Revised Compliant Scheme. (see No 16 precedents also No 81 + No(2).

To Satisfy 6160/APP/2019/3638 Amended.

Rev May 2020 R2

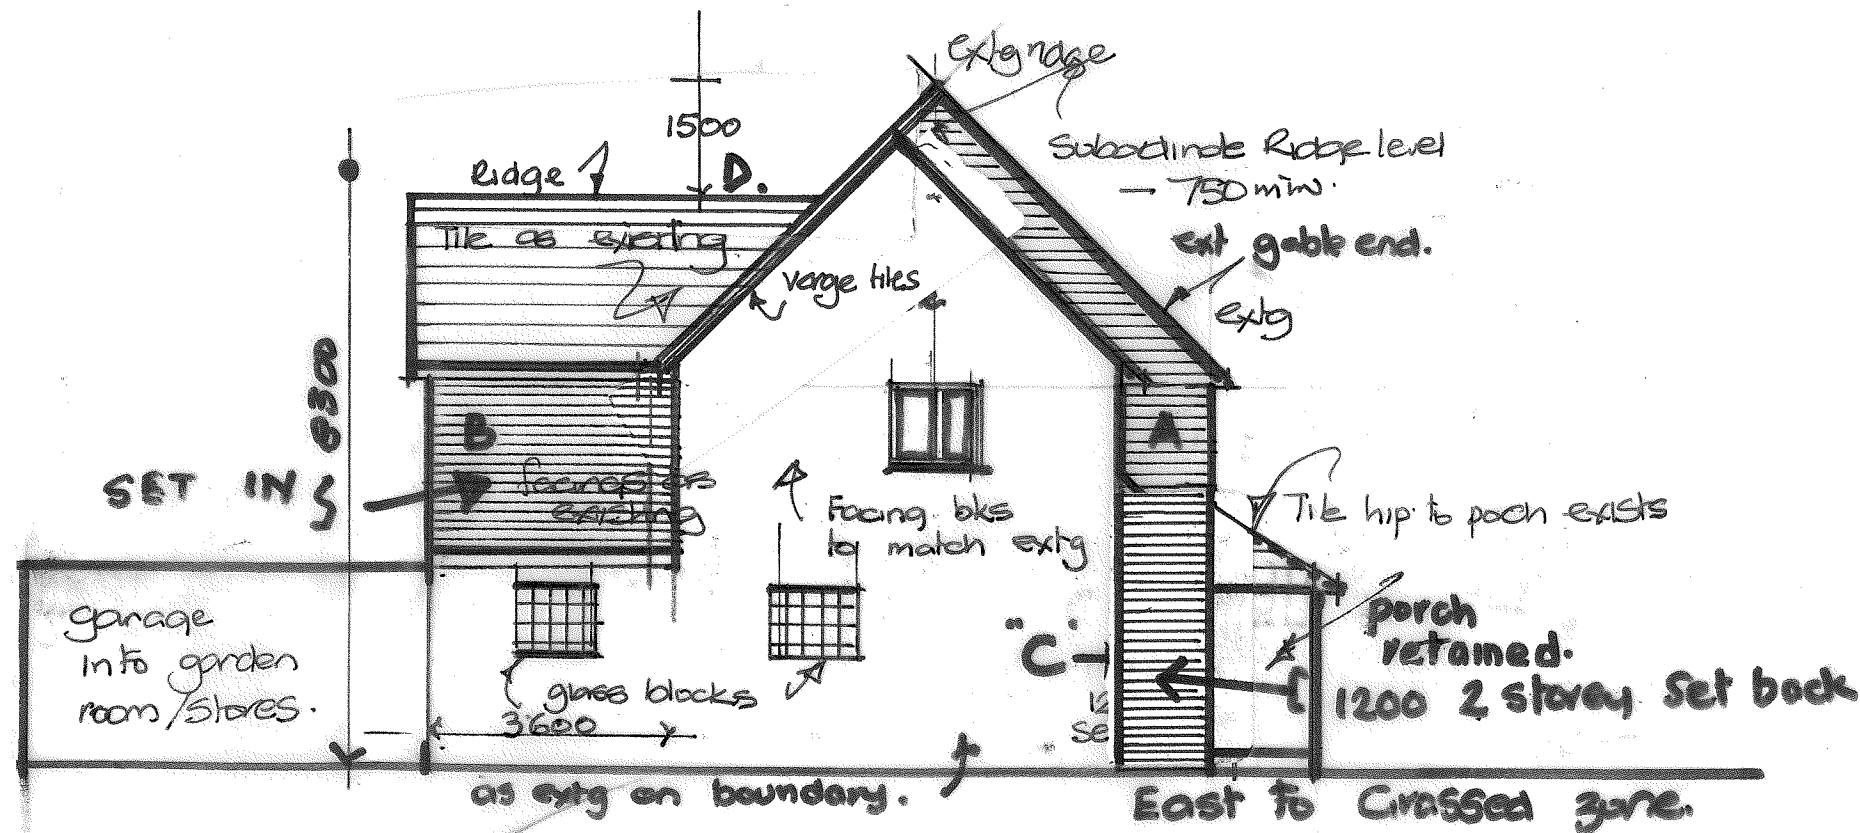
(1.) retain porch. Set back front upper by 1:2000 Subordinate ridge. See No 16 Colridge exact same but smaller Scale. bulk depth of rear extn. See additional photo Aid.

Revisions 15/5/2020. Compliant L.B & H. requirements. Drop ridge D. recess B. 3.6 x 900 at side reduces bulk etc. C + A Set back 1.2 on both floors. (see Notes) R.

Side as proposed (as Precedent 16 *).

Note No 16 is larger in depth + rear extension. Built onto boundary..

* No 1. revised to be same front set back + dropped ridge. drop rear ridge D. and Set in 3.6 mm.

No 16 Colridge Way
Principle precedent

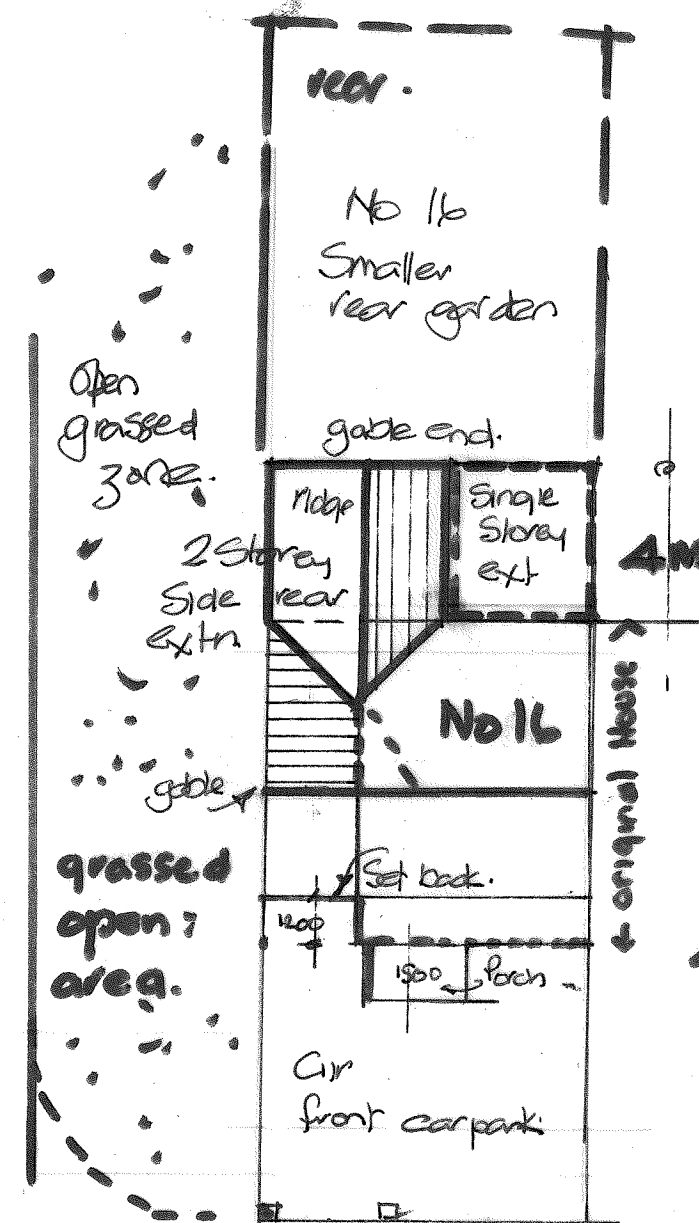
1:200 precedent see relationship. Same principles. only boundary 16 larger depth. + extn 4mtrs.

No 16
2 bed side flank
ext + rear inner
4mt. Single storey
extn.
Front set back
1:200
Subordinate ridge
